Ref. B2Gold Nunavut 2AM-BRP1831

Subject Landfarm Notification Memo – Responses to Supplemental Information Request

Interested Party:	Crown Indigenous & Northern Affairs Canada (CIRNAC)	TRC NO.:	CIRNAC-R-01
Re:	B2Gold Nunavut – Goose Mine – Landfarm: Erosion and Sediment Control Measures

**B2GOLD CORP.
GOOSE LAKE LAND FARM
BACK RIVER, NUNAVUT
ISSUED FOR PERMIT
APRIL 22, 2026**

Drawing No.
2500548-C1.2

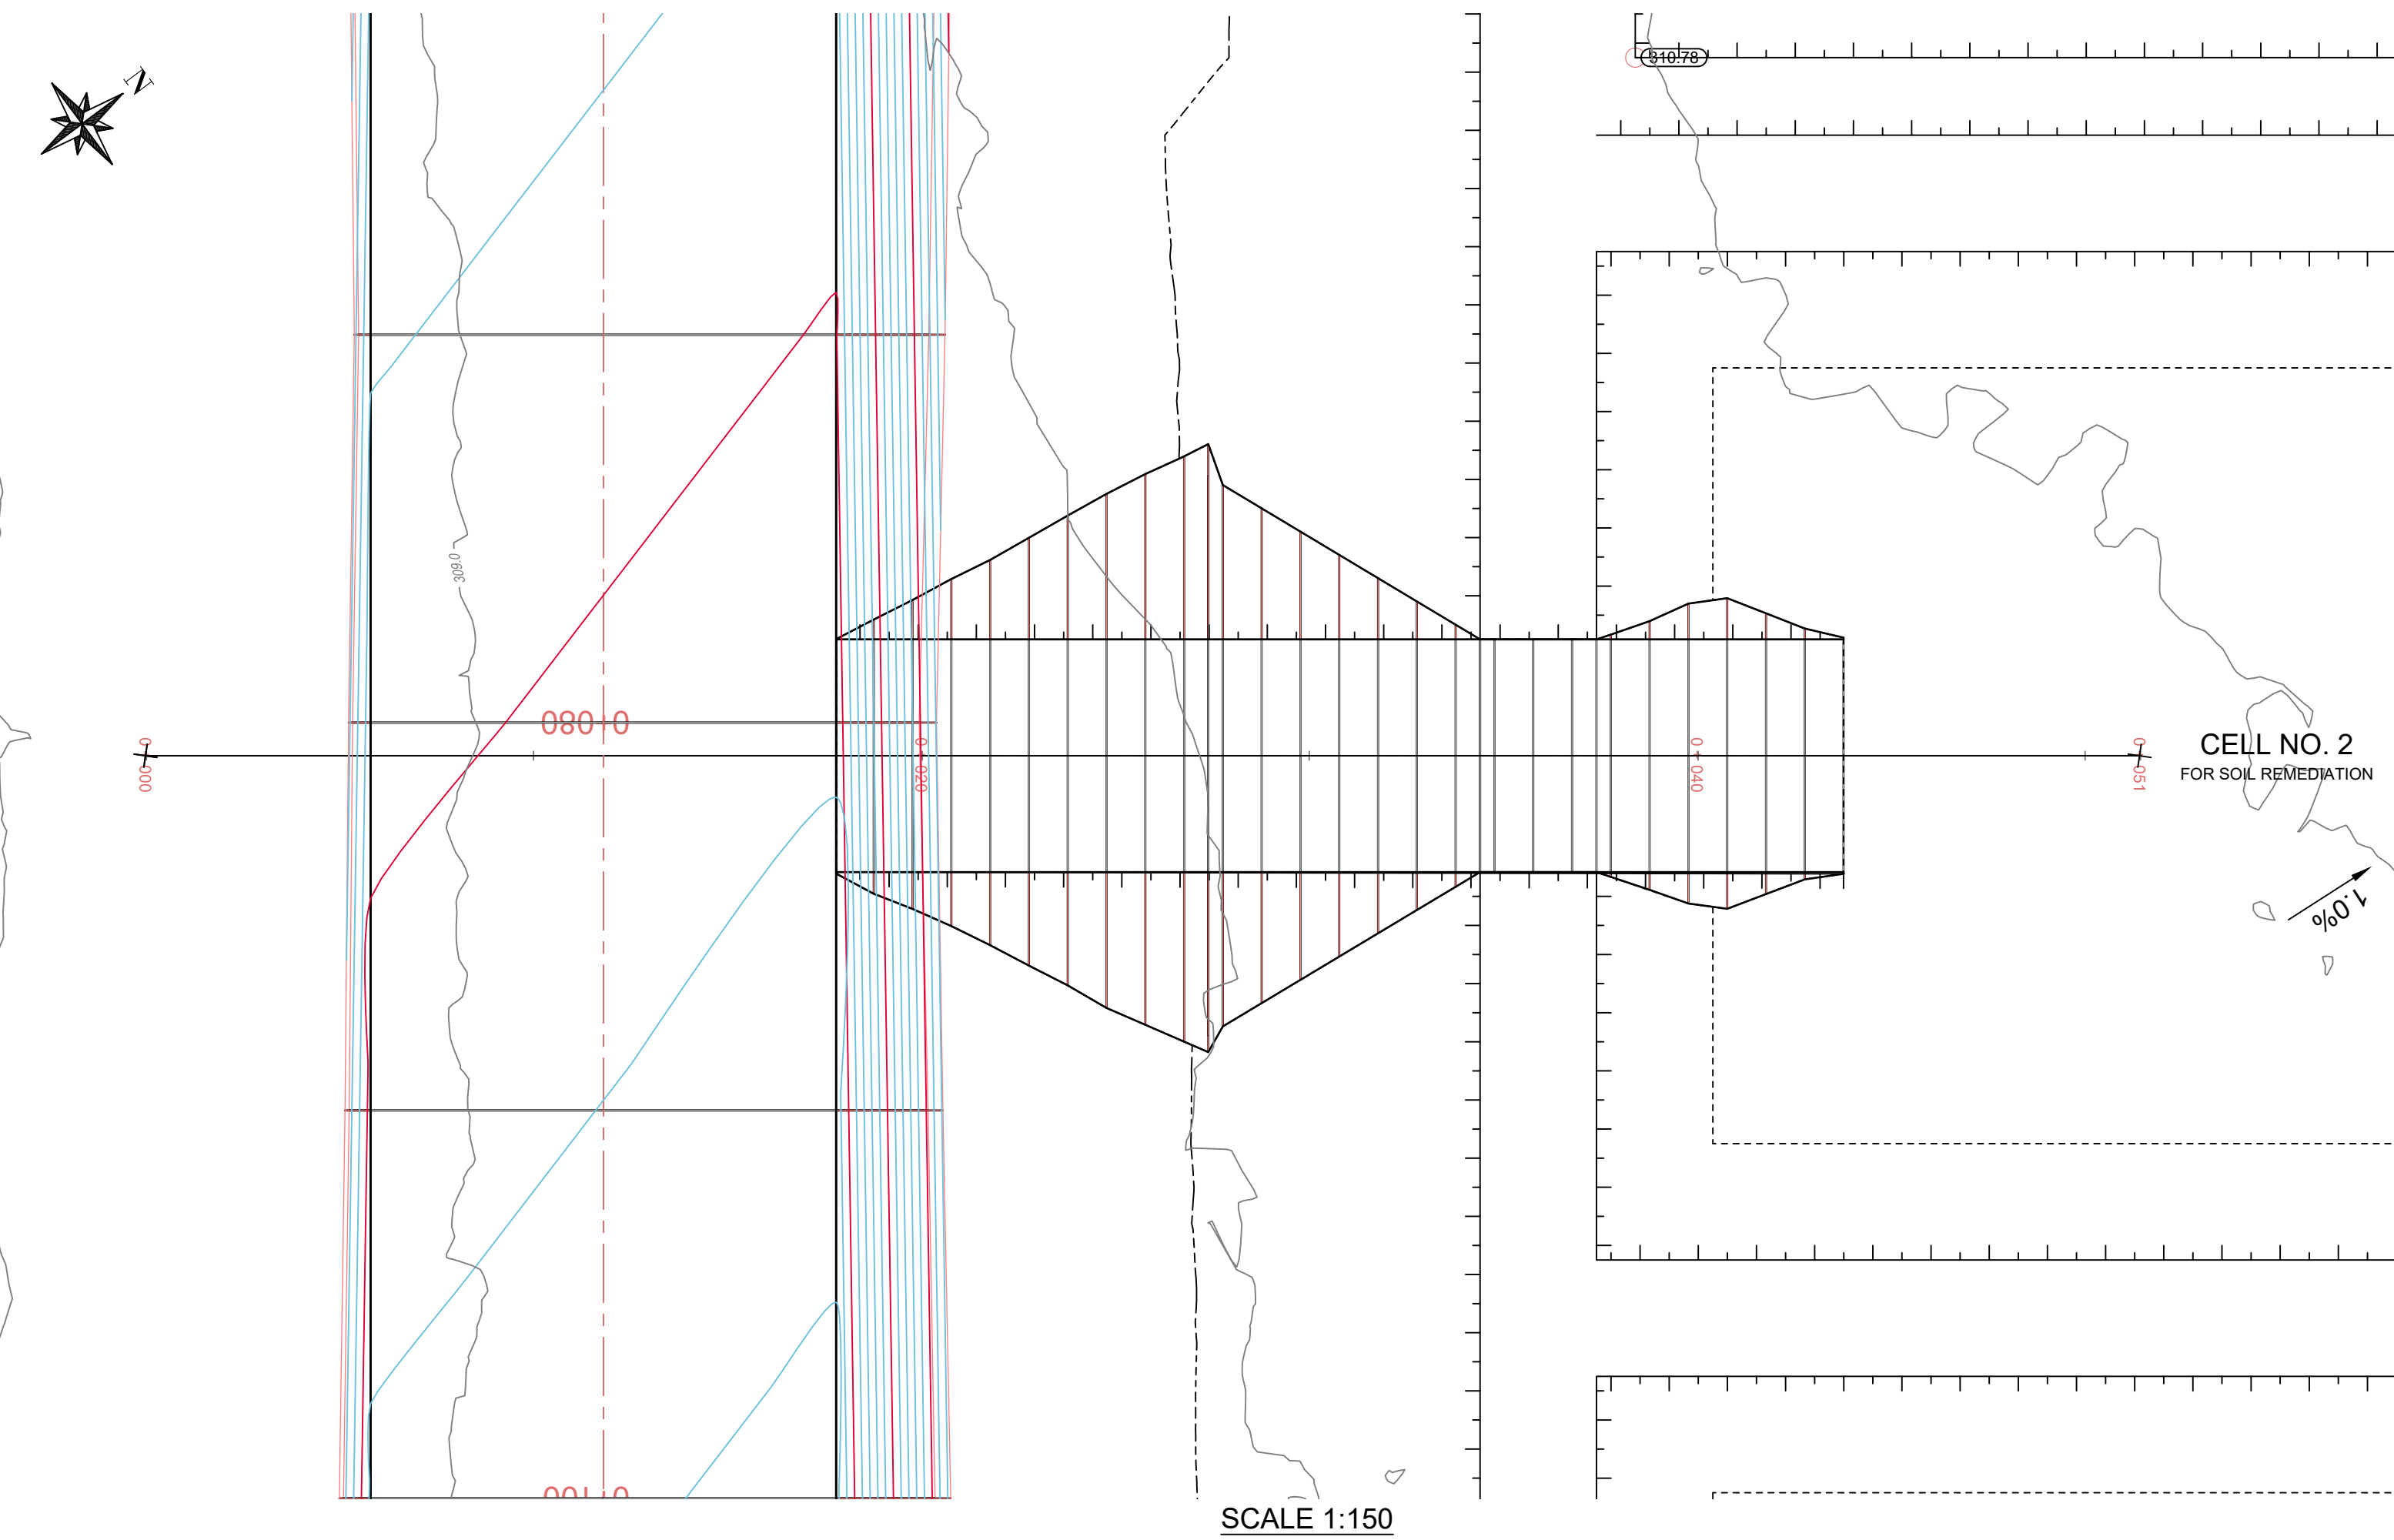
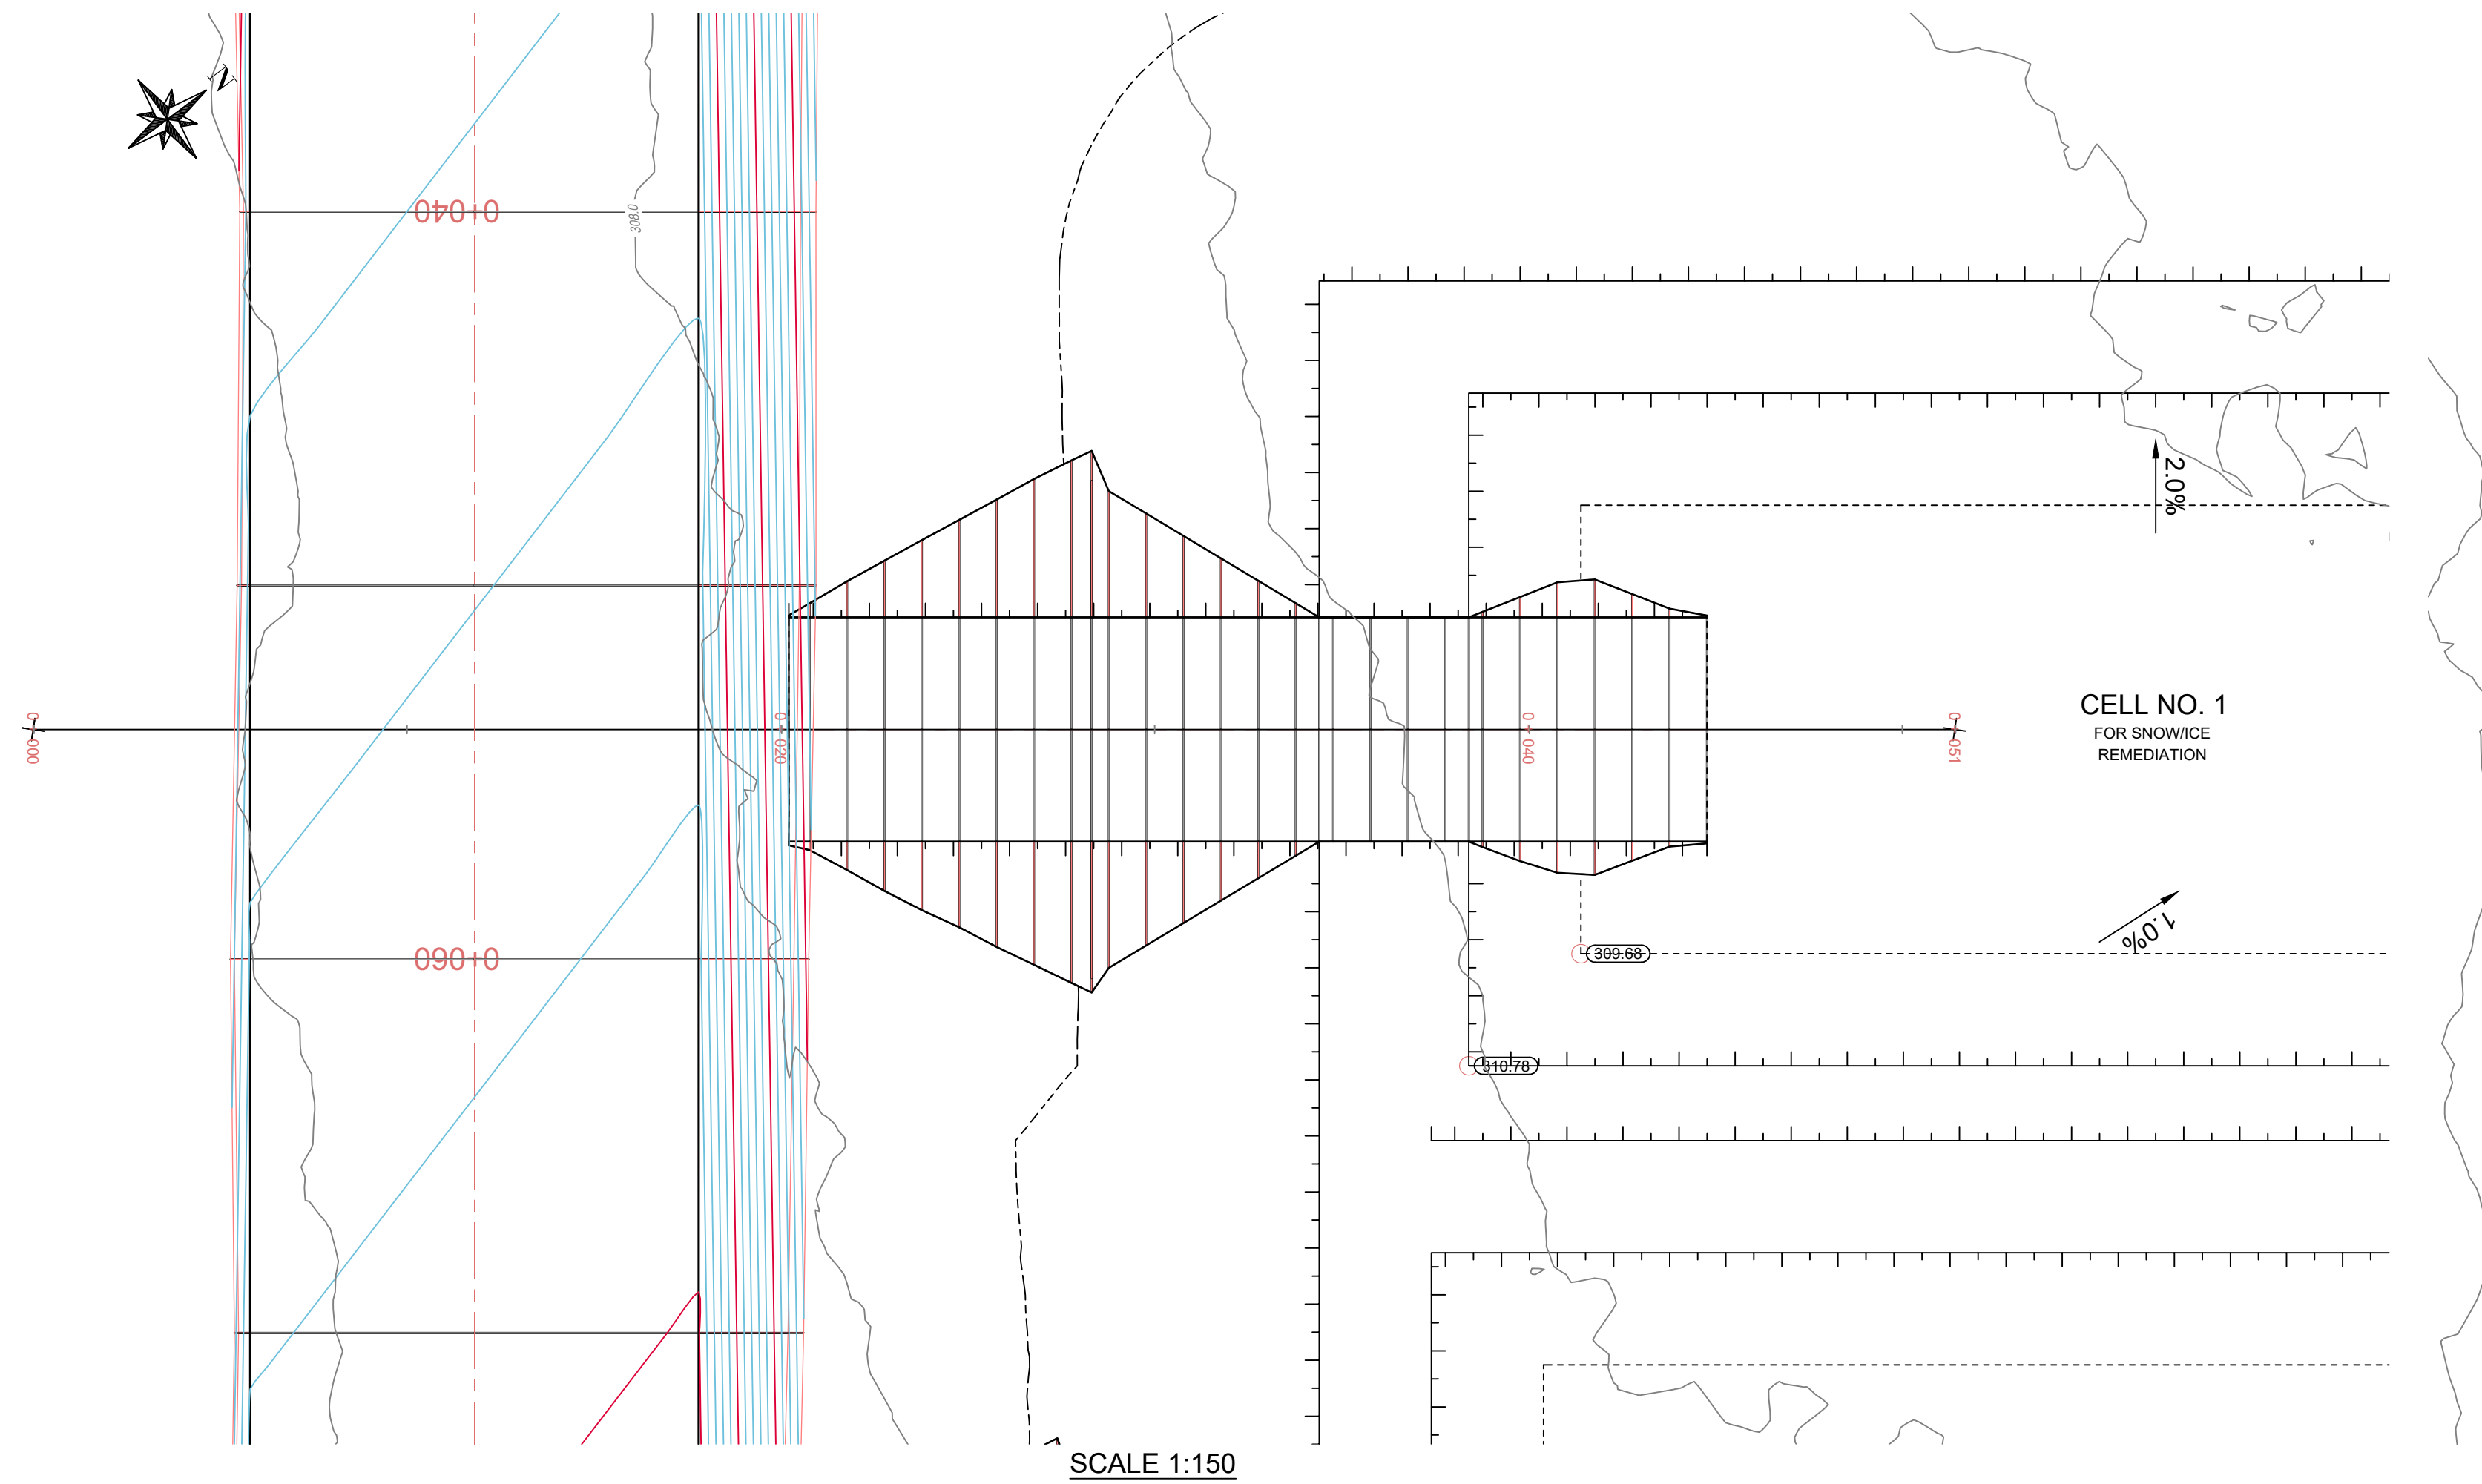
Access roads are mentioned in section 5.2.1 but are not mentioned or defined in any other section. CIRNAC is concerned access roads will be necessary to carry out the construction and operation of the Facility.

(R-03) CIRNAC recommends that B2Gold clarify whether the access roads will be included in this application or an additional one. Additionally, for either case, CIRNAC recommends the access roads be described and shown in the plan with dimensions.

- The Landfarm will be accessed via an existing all-weather site road and a new access road, which will form part of a pad expansion, will be constructed to gain access to the cells. The “pad expansion” is part of a separate submission for a new Waste Management Facility.
- The existing access road is constructed of crushed non-acid generating rock material. The segment adjacent to the Landfarm is shown in the updated drawing (Appendix A).
- While this area will eventually be integrated into a larger, future Waste Management Facility (currently under design for a separate submission to the NWB), the current Landfarm operations will utilize the existing road network.

Please refer to the drawing (Appendix A) which includes the access road dimensions and location relative to the Landfarm footprint.
